Form 3160-5
(June 2019)

SUNDRY NOTICES AND REPORTS ON WELLS
Do not use this form for proposals to drill or to re-enter an abandoned well. Use Form 3160-3 (APD) for such proposals.

8. Well Name and No. **ANTIETAM 9 FED COM/581H**

Antietam 9 Fed Com 228H (FKA 581H) API #: 30-025-52260

Revised Wellbore A:

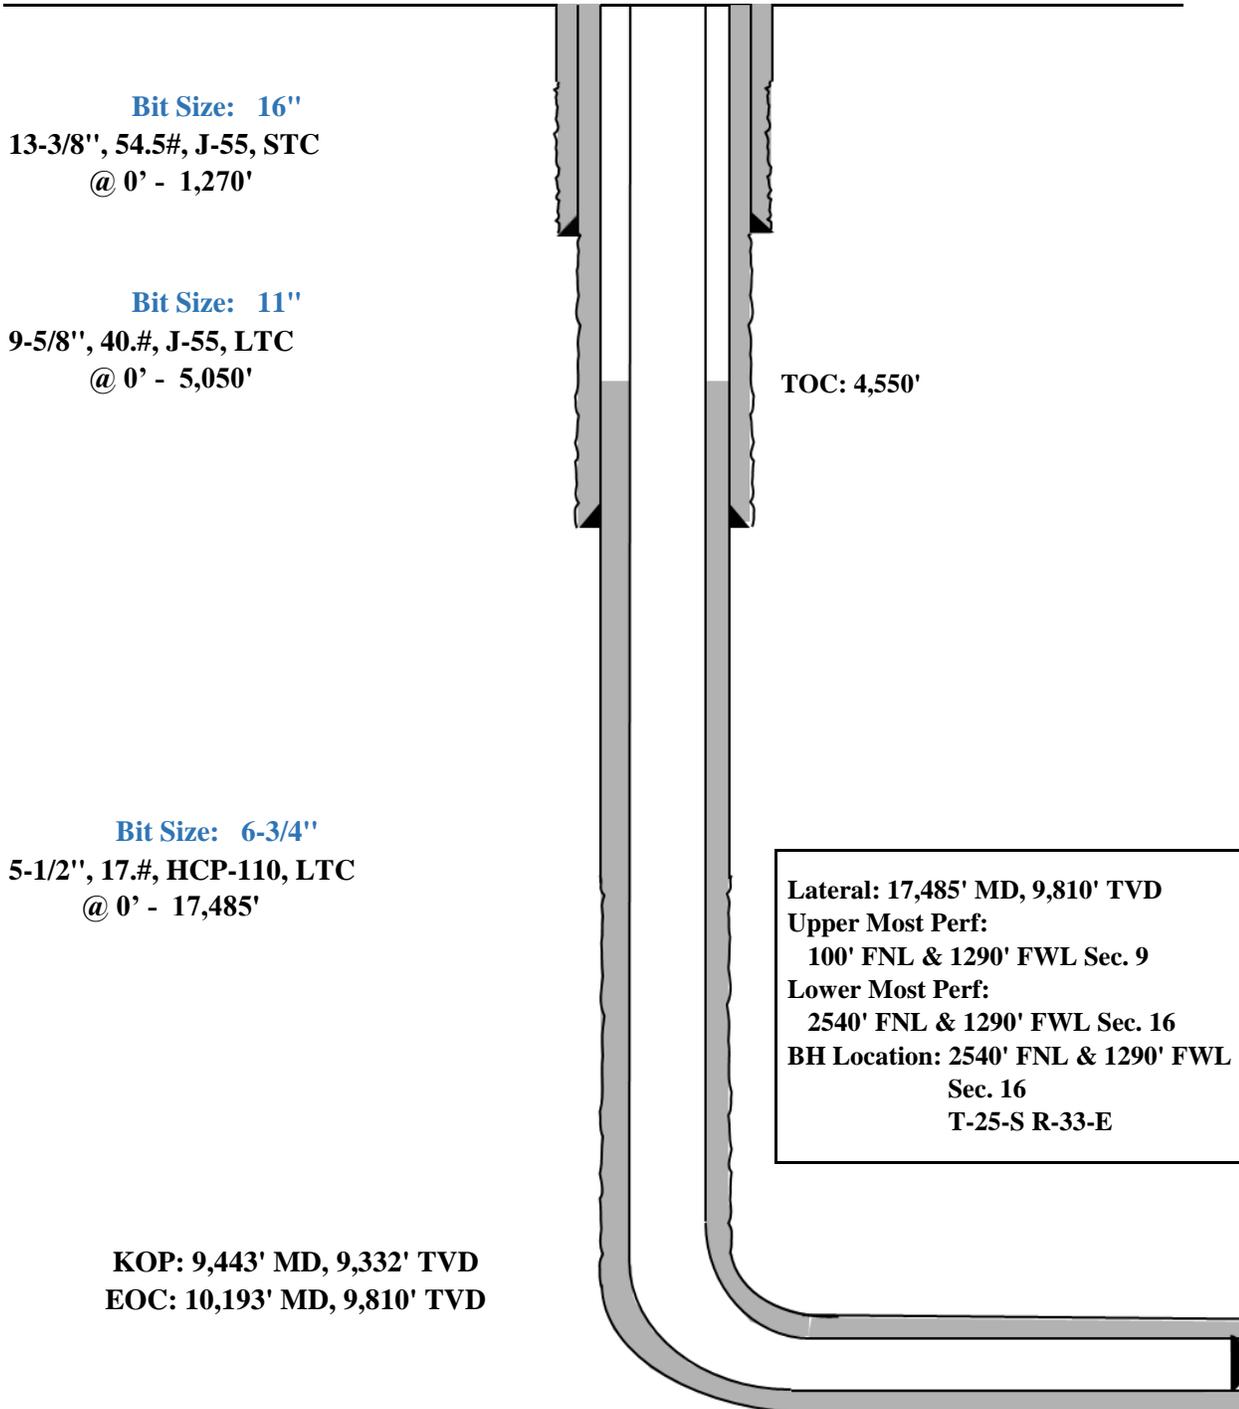
EOG respectfully requests an amendment to our approved APD for this well to reflect the following changes:

Change name from Antietam 9 Fed Com 581H to Antietam 9 Fed Com 228H.

Change BHL from T-25-S, R-33-E, Sec 16, 2540' FNL, 700' FWL, Lea Co., NM, to T-25-S, R-33-E, Sec 16, 2540' FNL, 1290' FWL, Lea Co., N.M.

Change target formation to Leonard B.

Update casing and cement program to current design.

13-3/8", 54.5#, J-55, STC
@ 0' - 1,270'

9-5/8", 40.#, J-55, LTC
@ 0' - 5,050'

5-1/2", 17.#, HCP-110, LTC
@ 0' - 17,485'

Lateral: 17,485' MD, 9,810' TVD
 Upper Most Perf:
 100' FNL & 1290' FWL Sec. 9
 Lower Most Perf:
 2540' FNL & 1290' FWL Sec. 16
 BH Location: 2540' FNL & 1290' FWL
 Sec. 16
 T-25-S R-33-E

Revised Wellbore B:

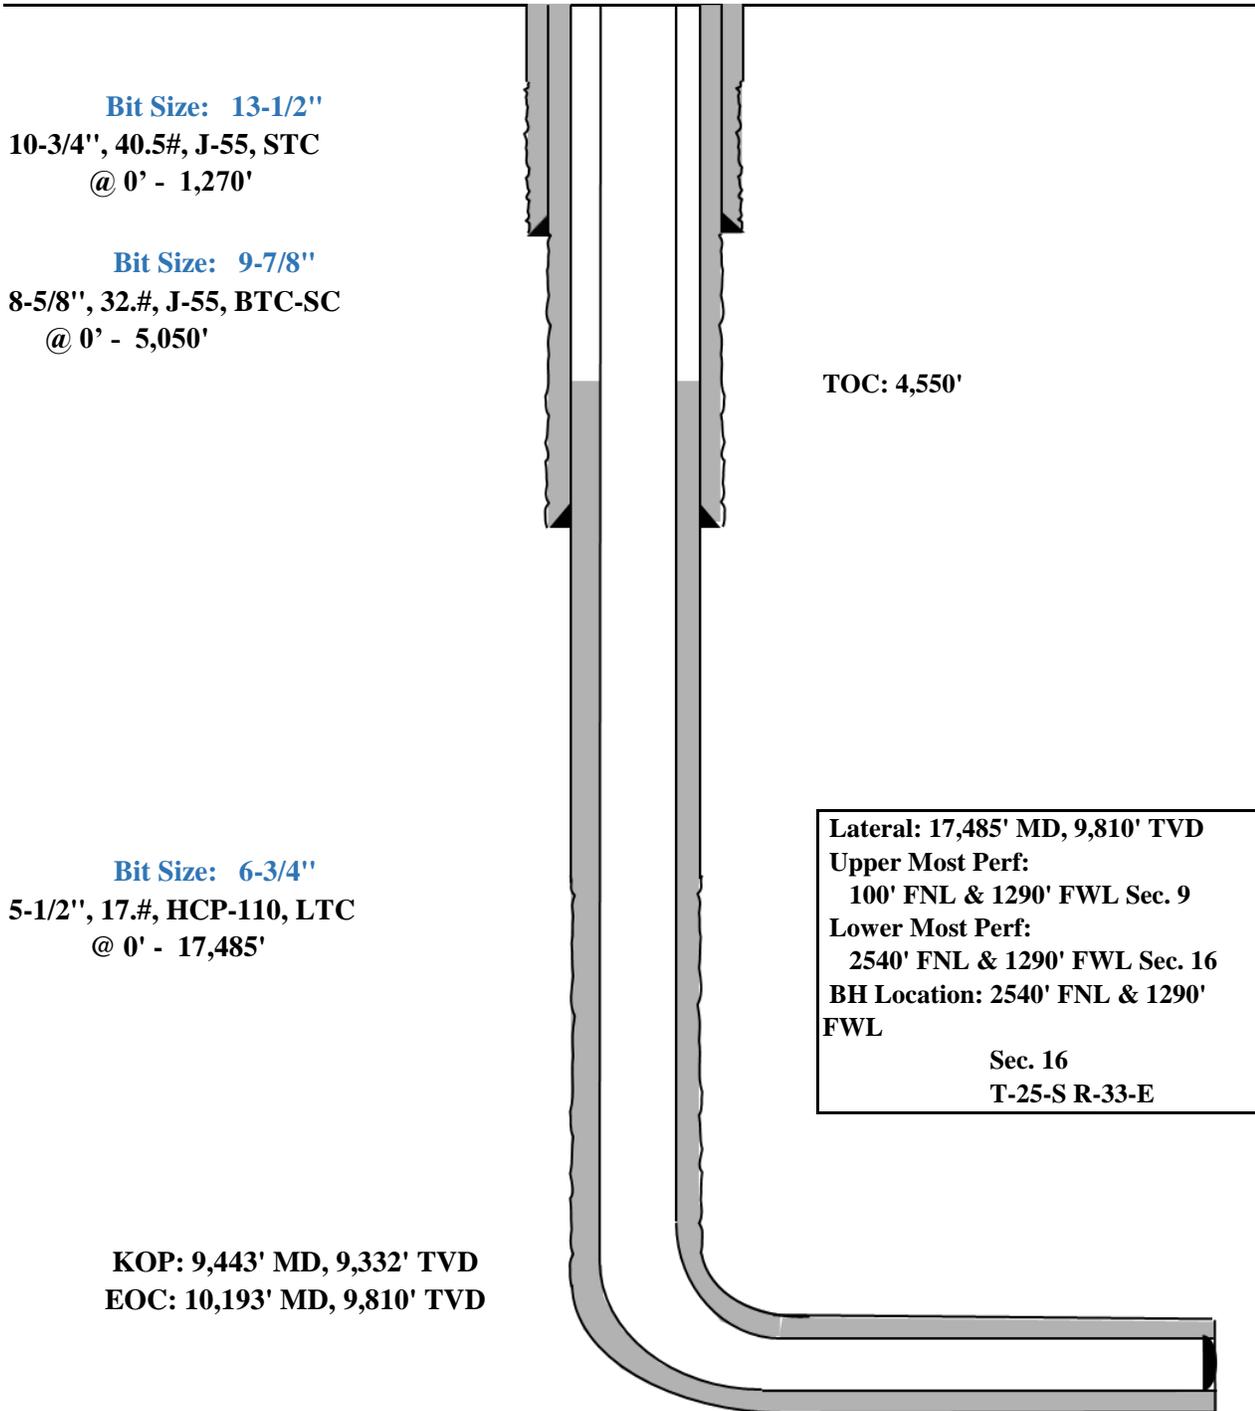
Casing Program B:

Variance is requested to waive the centralizer requirements for the 8-5/8" casing in the 9-7/8" hole size. An expansion additive will be utilized, in the cement slurry, for the entire length of the 9-7/8" hole interval to maximize cement bond and zonal isolation.

Variance is also requested to waive any centralizer requirements for the 5-1/2" casing in the 6-3/4" hole size. An expansion additive will be utilized, in the cement slurry, for the entire length of the 6-3/4" hole interval to maximize cement bond and zonal isolation.

Bit Size: 13-1/2"
 10-3/4", 40.5#, J-55, STC
 @ 0' - 1,270'

Bit Size: 9-7/8"
 8-5/8", 32.#, J-55, BTC-SC
 @ 0' - 5,050'

Bit Size: 6-3/4"
 5-1/2", 17.#, HCP-110, LTC
 @ 0' - 17,485'

Lateral: 17,485' MD, 9,810' TVD
Upper Most Perf:
100' FNL & 1290' FWL Sec. 9
Lower Most Perf:
2540' FNL & 1290' FWL Sec. 16
BH Location: 2540' FNL & 1290'
FWL
Sec. 16
T-25-S R-33-E
